The Citation Twelve/Citation Twelve Deluxe

Technical Manual

ADDENDUM TO CITATION TWELVE TECHNICAL MANUAL

REVISED SECTION

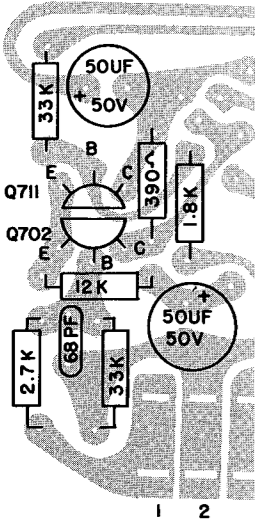
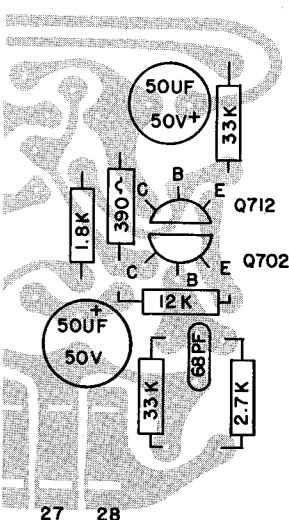
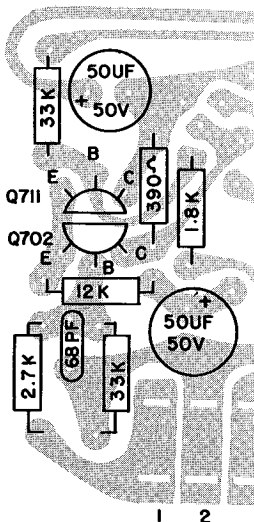
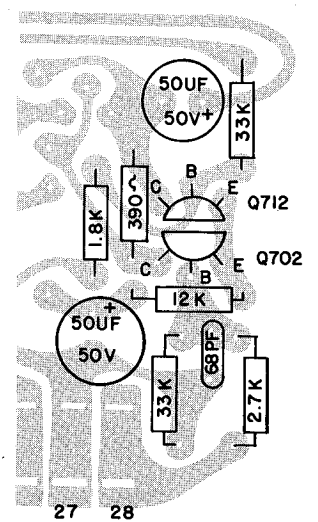
NOTE: ALSO SEE REVISED SECTION ON
P.C. BOARD (PAGE 4 & 5)

REVISED SCHEMATIC SECTIONS

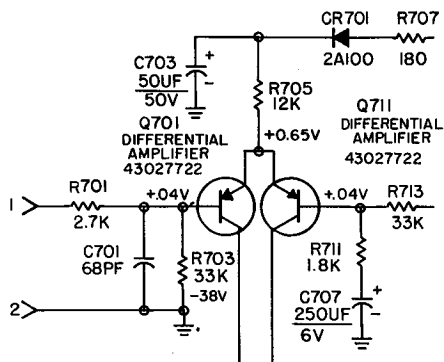
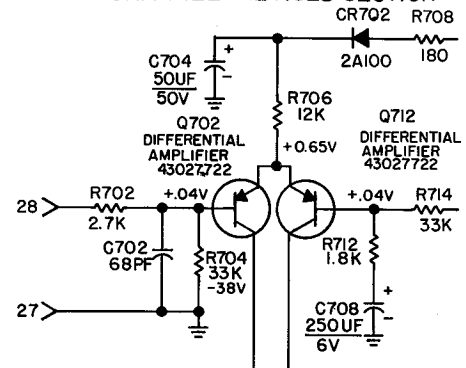
CIRCUIT REF.	DESCRIPTION	HK PART NO.	DESCRIPTION	HK PART NO.
DIODES				
CR7, CR8	Rectifier, Full Wave Bridge	41027230	FUSES AND CIRCUIT BREAKER	
			Fuse, Line 3A-3AG	45013291
TRANSISTORS				
Q701, Q702	Differential Amplifier	43027722	MISCELLANEOUS	
Q711, Q712	Differential Amplifier	43027722	Fuse Holder w/Hardware	65427001
			Line Cord	53026355
			Rubber Foot	62011692
RESISTORS				
R705, R706	Carbon Comp. 12K $\pm 10\%$ 1/2 W	33311231 <i>70L</i>

Q NUMBER	H.K. PART NUMBER	COMMERCIAL EQUIVALENT
701, 702	43027722	2N5807 <i>5087</i>
703, 704	43024306	RCA 40408
705, 706	43024219	RCA 40595
707, 708	43023221	2N5232
709, 710	43024218	RCA 40594
711, 712	43027722	2N5807
1,2,3,4	43024216	RCA 40636

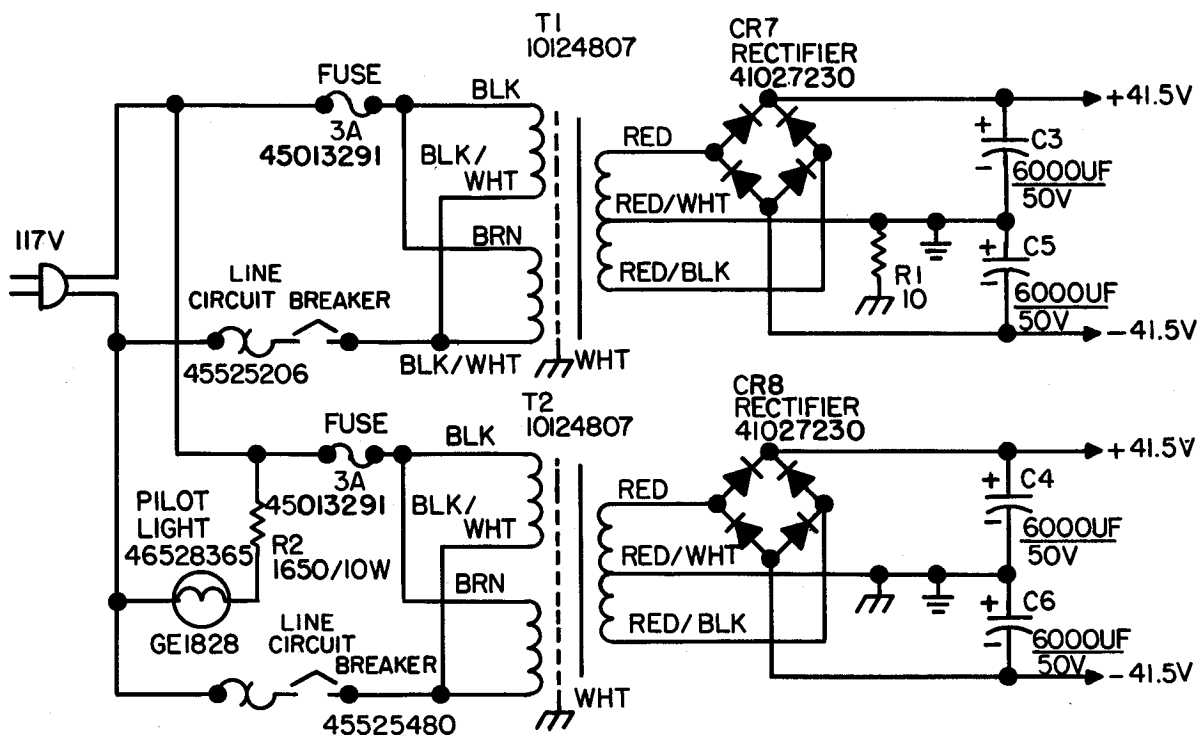
2. The schematic on page 3 is modified as shown below.
